Re: 4 Right 4 East Panel Amendment, Canyon Fuel Company, LLC, Sufco Mine, Permit Number
C/041/0002

APPLICATION FOR COAL PERMIT PROCESSING

Detailed Schedule Of Changes to the Mining And Reclamation Plan

Mine: Sufco Mine, Amendment to MRP to Address the Mining of 4 Right 4 East Panel(s)

SUFCO MINE		
4R4E PANEL LAYOUT		
SCALE: 1" = 1000'	DATE: 9/25/2017	DRAWN BY: AMR
ENGINEER: AMR	CHECKED BY: BB	PROJ:
FILE NAME: J:\Mine Plans\2018\Budget\22nd Run\SufProd18_22ndRun.dwg

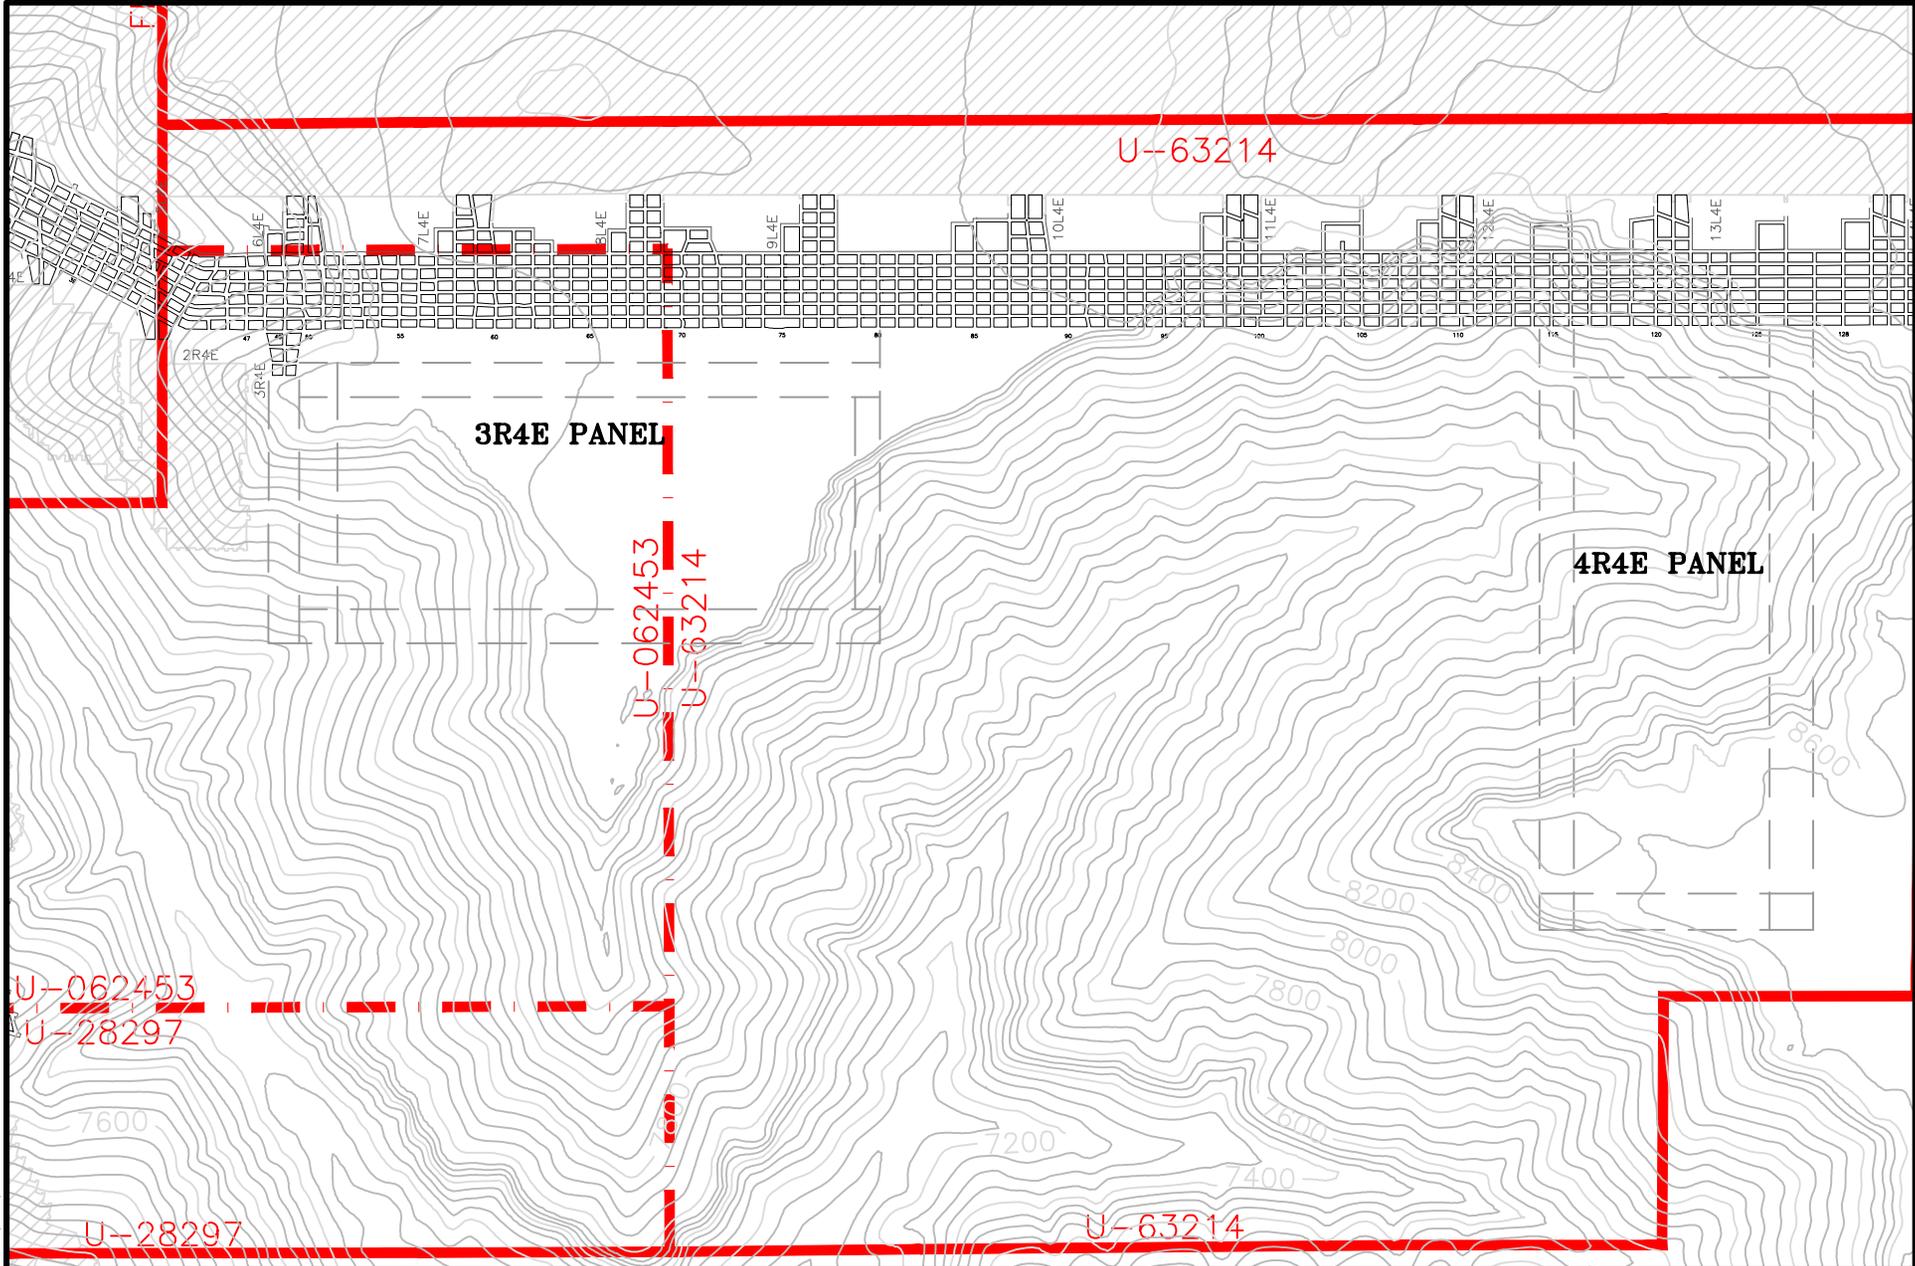
Please find enclosed with this letter a copy of an amendment to the Sufco Mine Permit in response to deficiencies regarding the 4 Right 4 East panel. The 4 Right 4 East Panel is located on the existing lease U-63214 which is part of the Quitchupah Tract/Lease. See Plate 5-7 for additional information regarding its location.

SCALE: 1" = 2,000' (03/01/2000)
 DATE: 03/01/2000
 DRAWN BY: B.D.H.
 ENGINEER: M.L.D.
 SHEET NO.: PLATE 5-2C

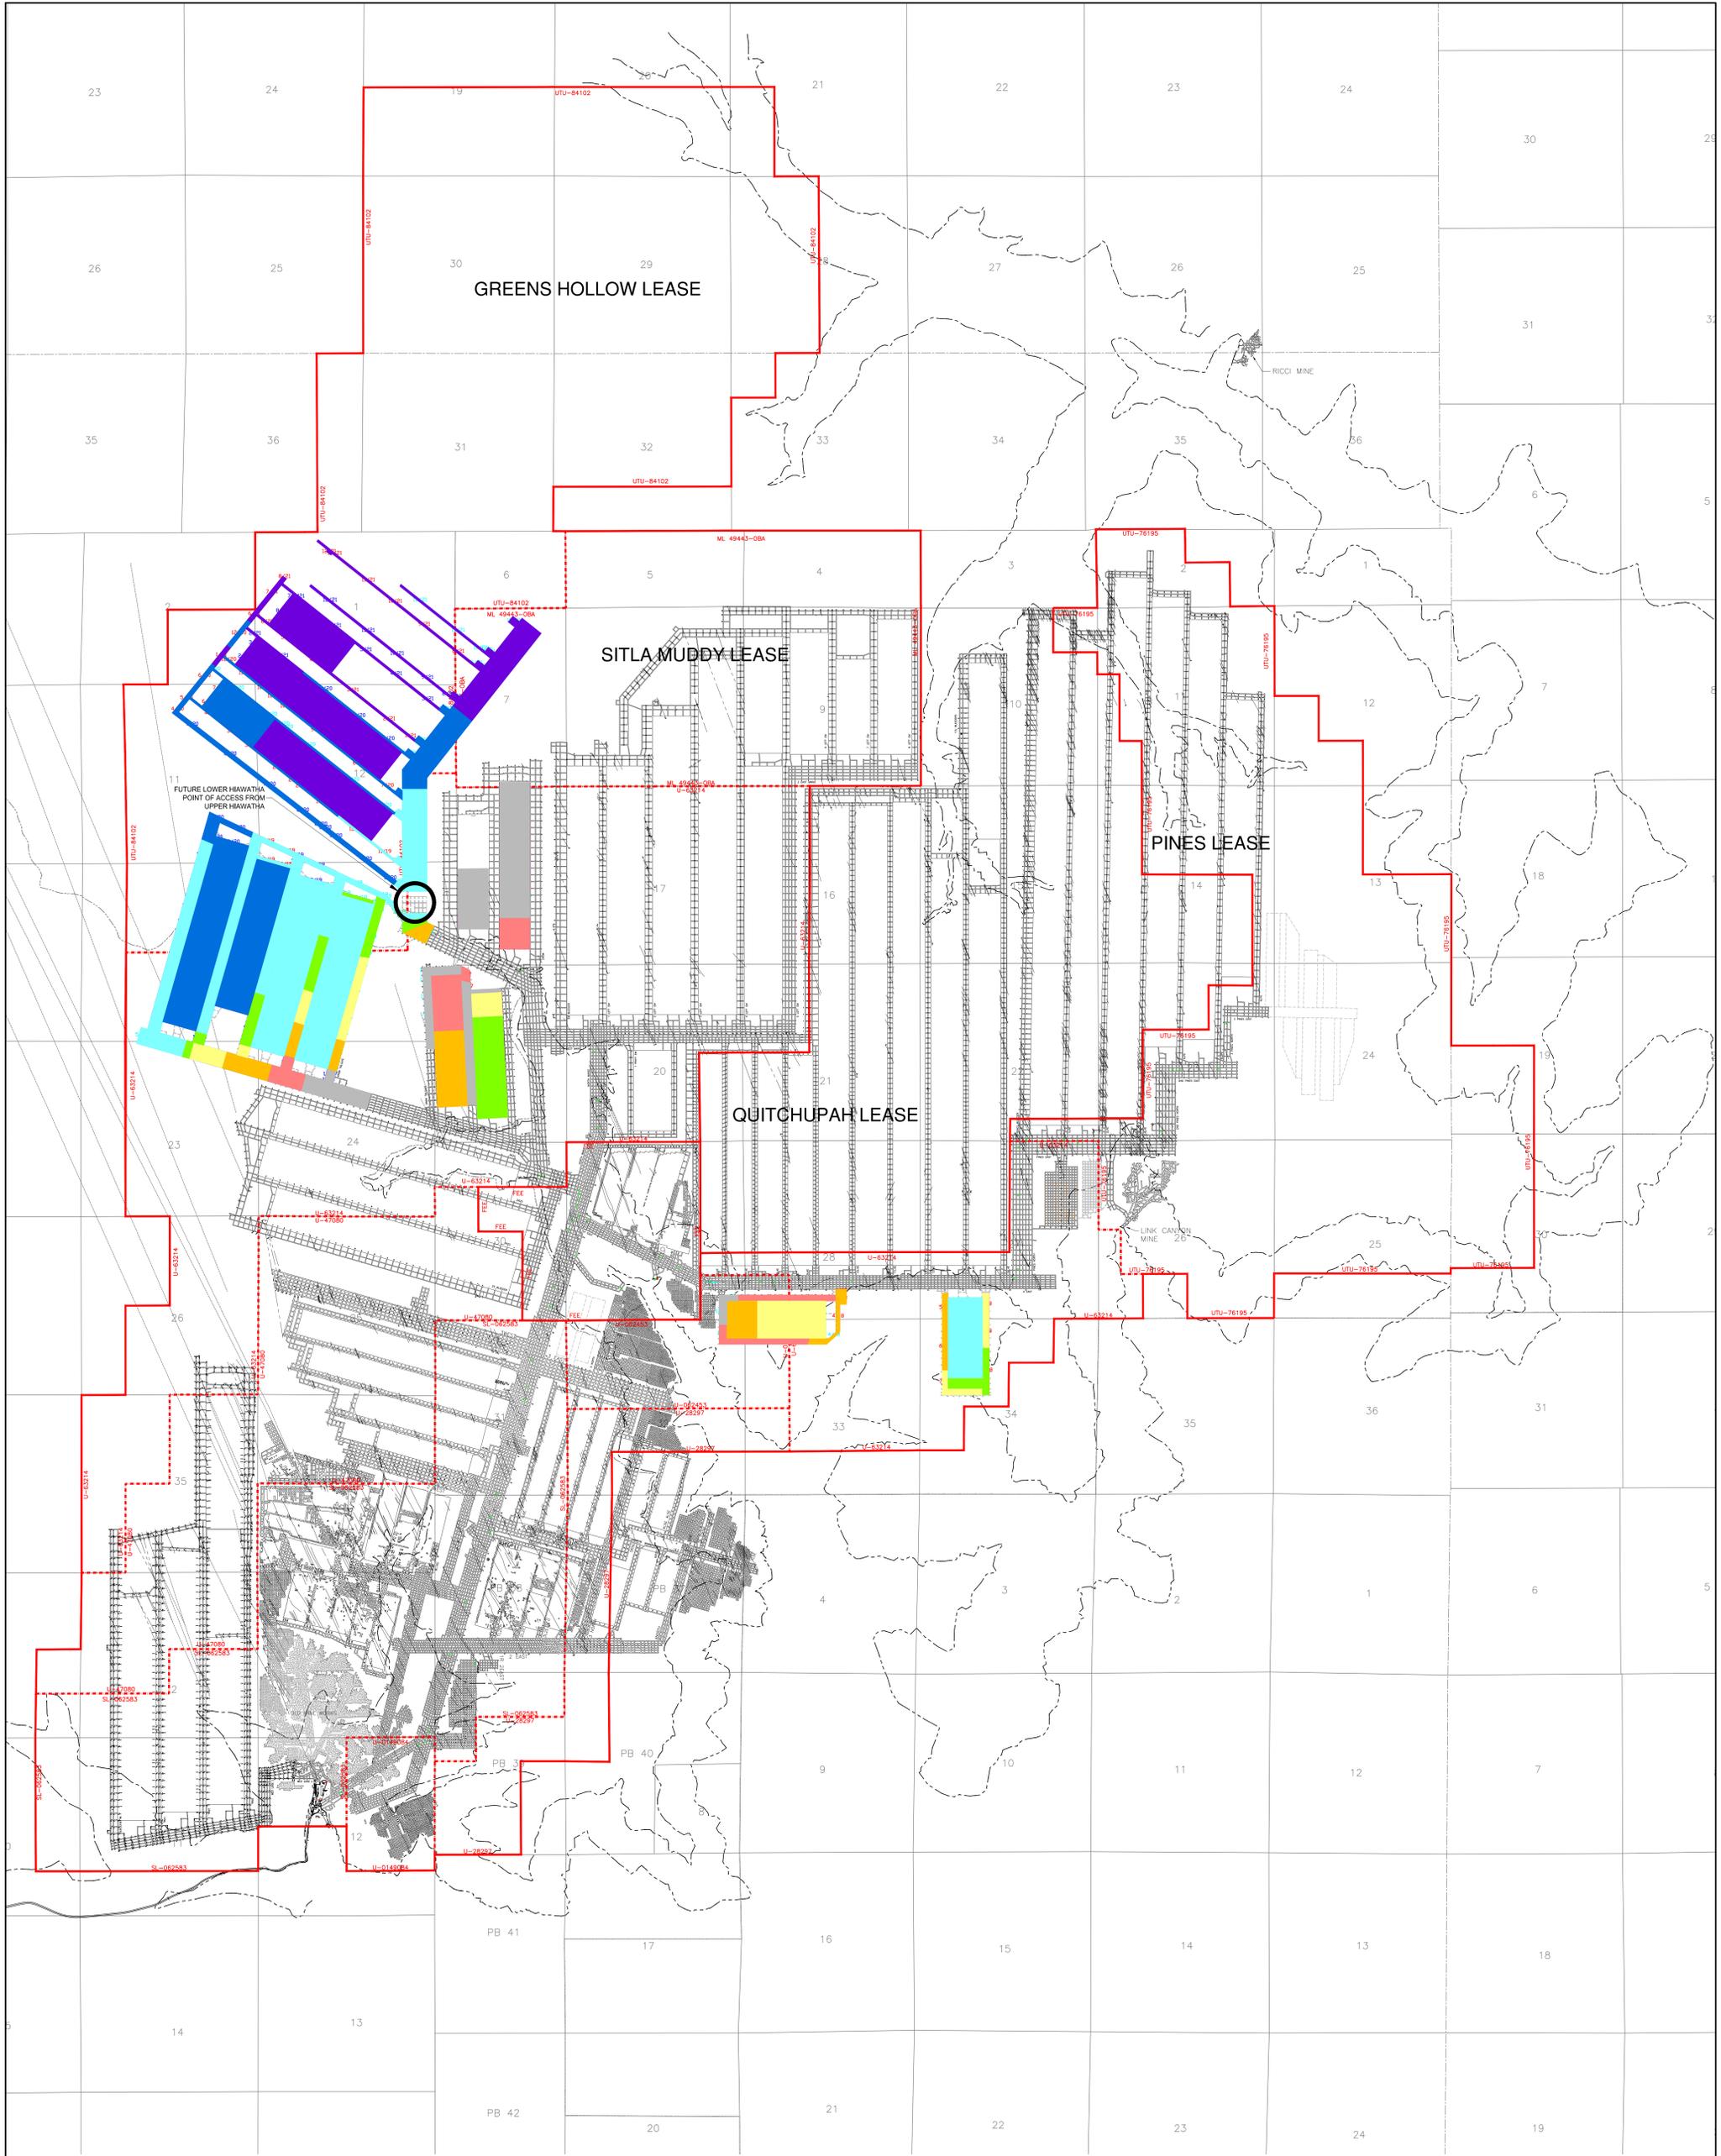
NO.		DATE		REVISED BY		REVISIONS		REMARKS	
1	4/13/2017	J.M.	S.K.						GREENS HOLLOW
2	10/23/2017	B.B.	B.K.						Add 4th Qtr Panel

POTENTIAL SUBSIDENCE LIMITS
SITLA MUDDY & GREENS HOLLOW TRACT

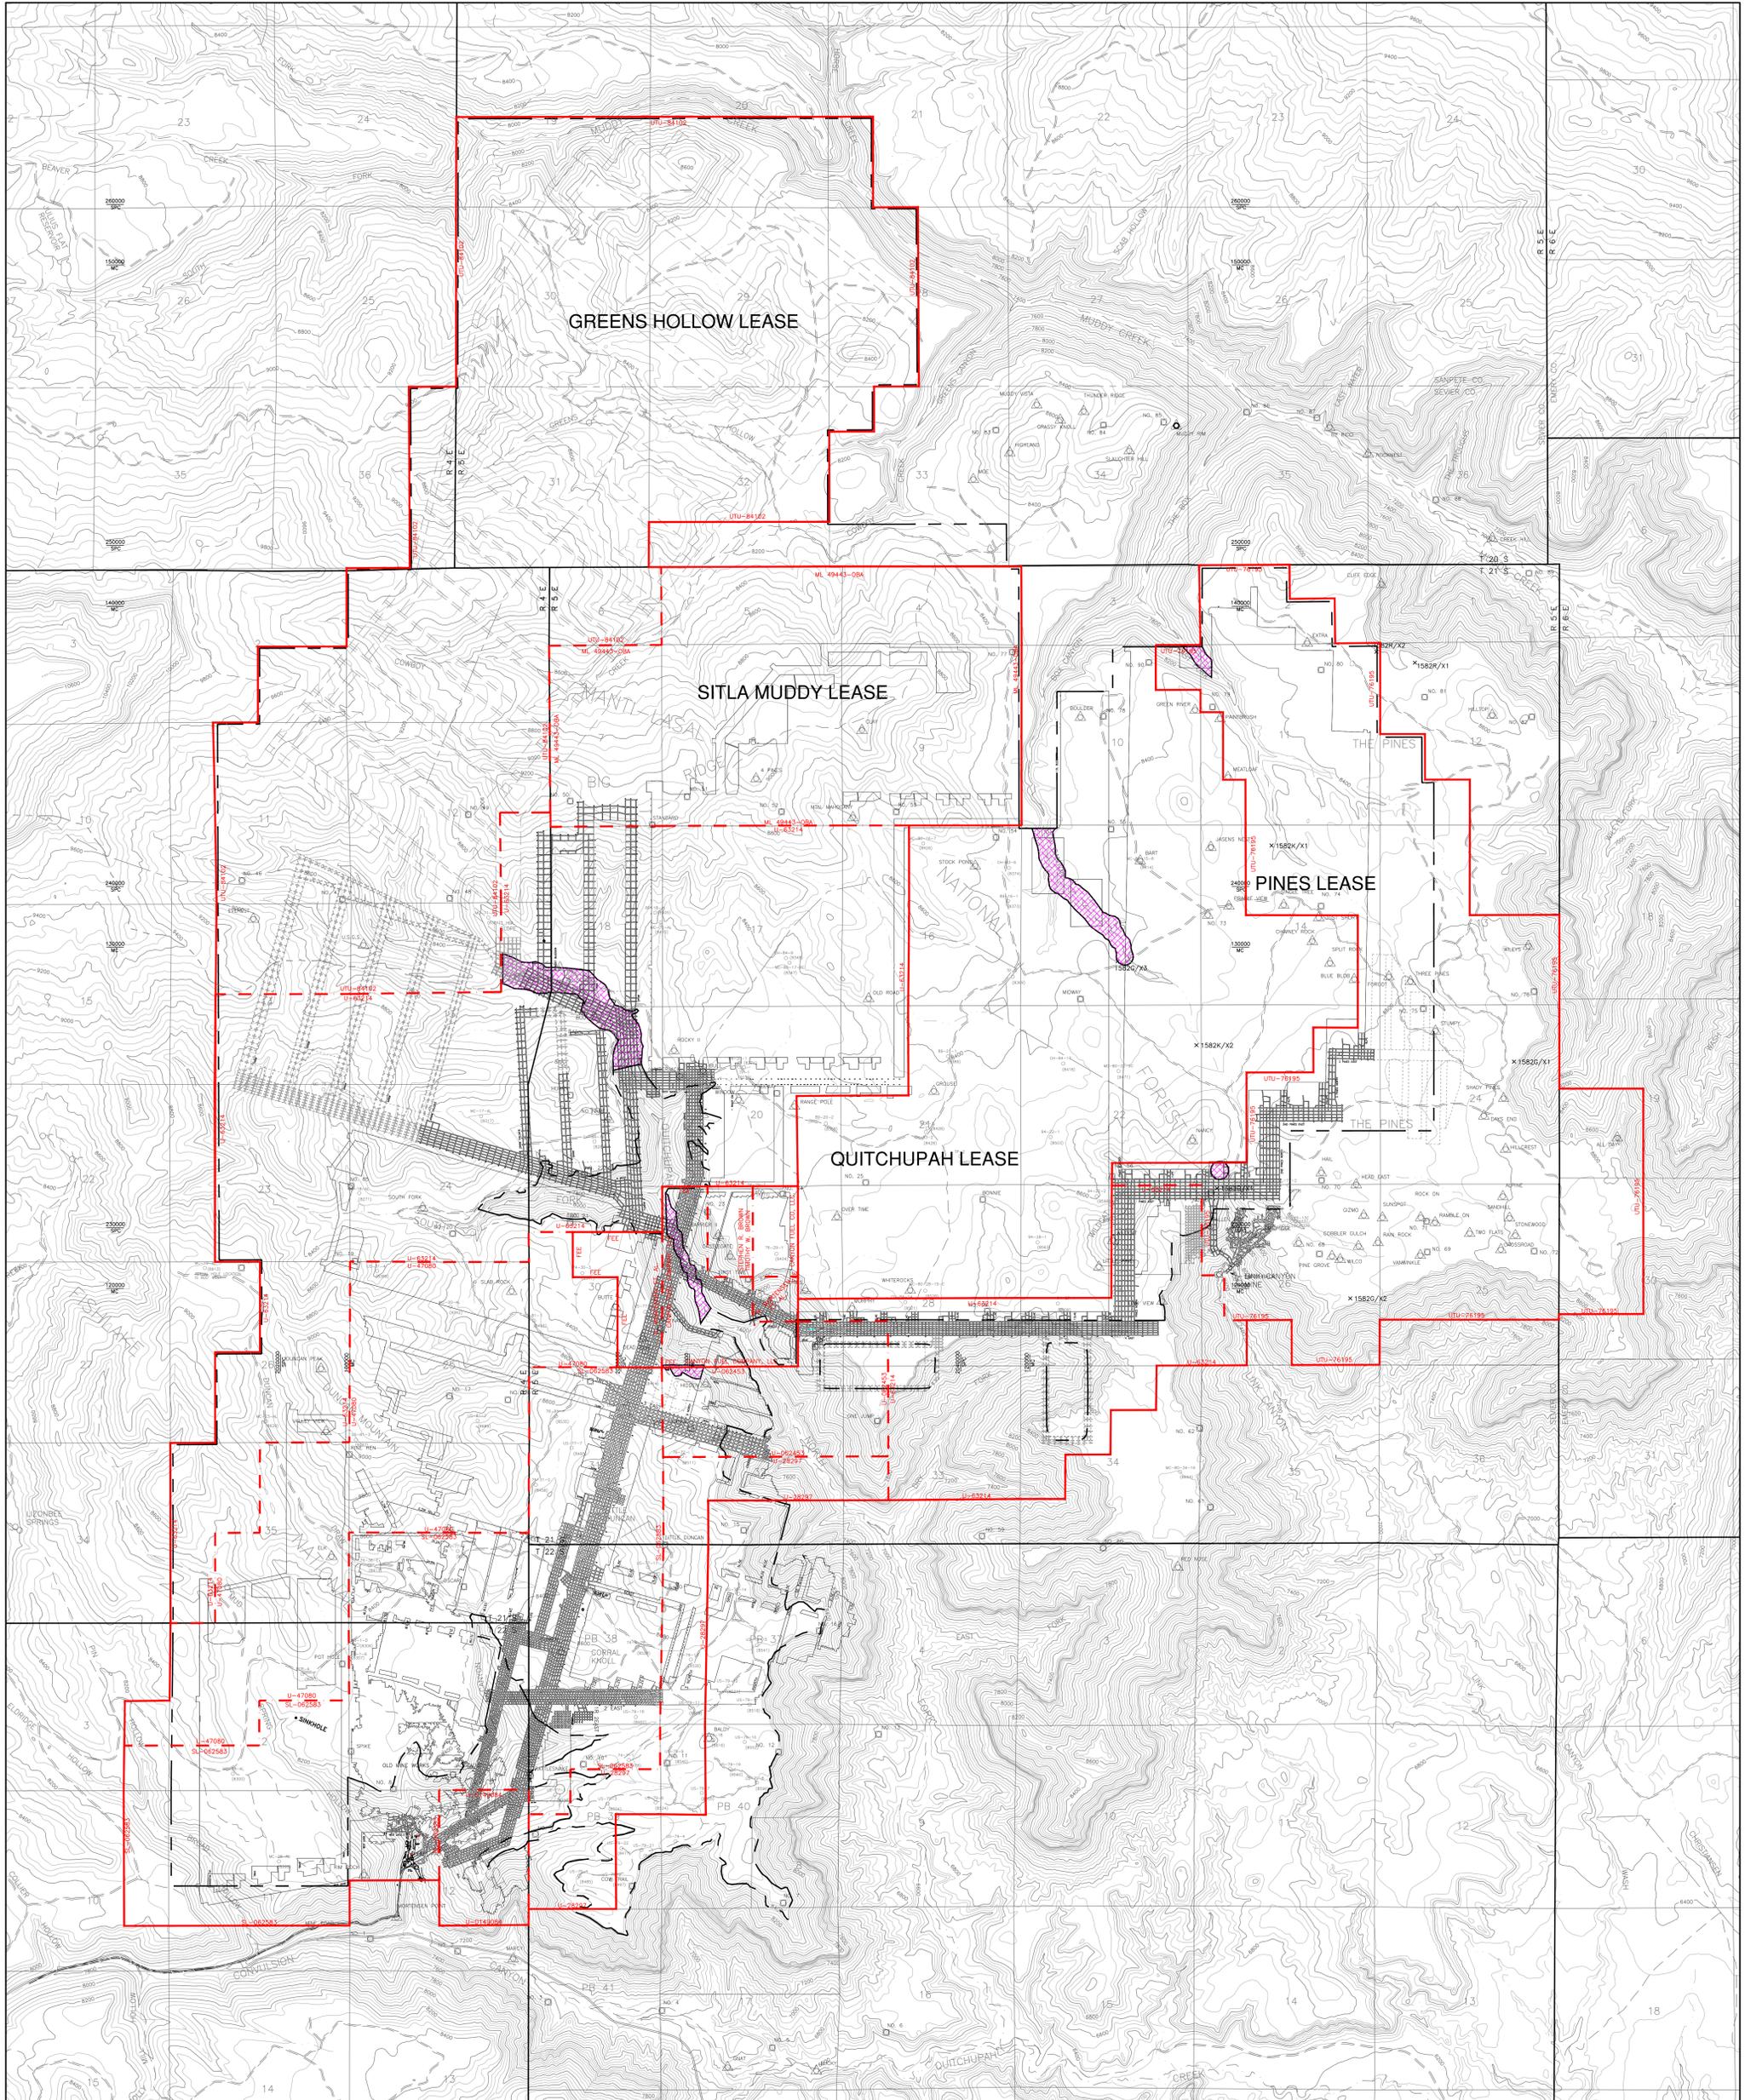
REVISIONS				
NO.	DATE	REQ. BY	DWG. BY	REMARKS
1	12/15/2016	VM	J.L.W.	REMOVE SOUTH FORK LEASE BOUNDARY
2	4/7/8/2017	VM	B.K.	GREENS HOLLOW
3	10/18/2017	BB	B.K.	ADD WIDE PAVES
